## Clarification on the proposal for a new Supplement to the 03 series of amendments to UN Regulation No. 53

This document intends to clarify the content of GRE/2019/23, aimed at ensuring that the new 03 series of amendments to UN Regulation No. 53 contains the latest proposals adopted by GRE regarding preceding series.

## "Annex 7

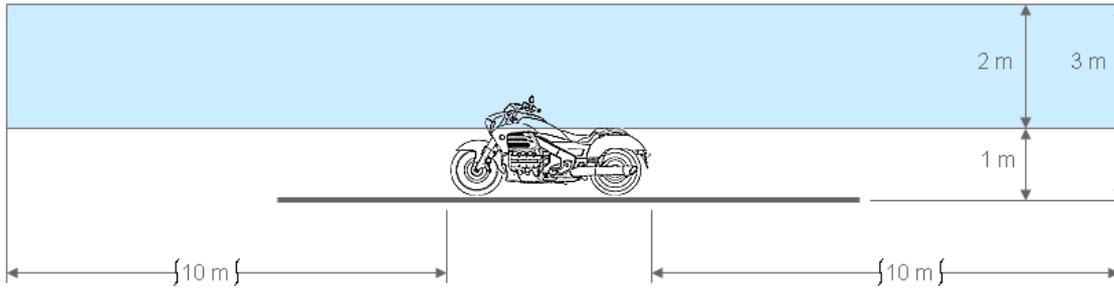
Insert a new Annex 7, to read:

### Observing area towards the apparent surface of exterior courtesy lamps

#### Zones of observation

This drawing shows the zone from one side, the other zones are from the front, the rear and from the other side of the vehicle.

observer moving on the boundary of a zone on a transverse plane 10 m from the front of the vehicle, a transverse plane 10 m from the rear of the vehicle, and two longitudinal planes 10 m from each side of the vehicle; these four planes to extend from 1 m to 3 m above and perpendicular to the ground as shown in Annex 7.
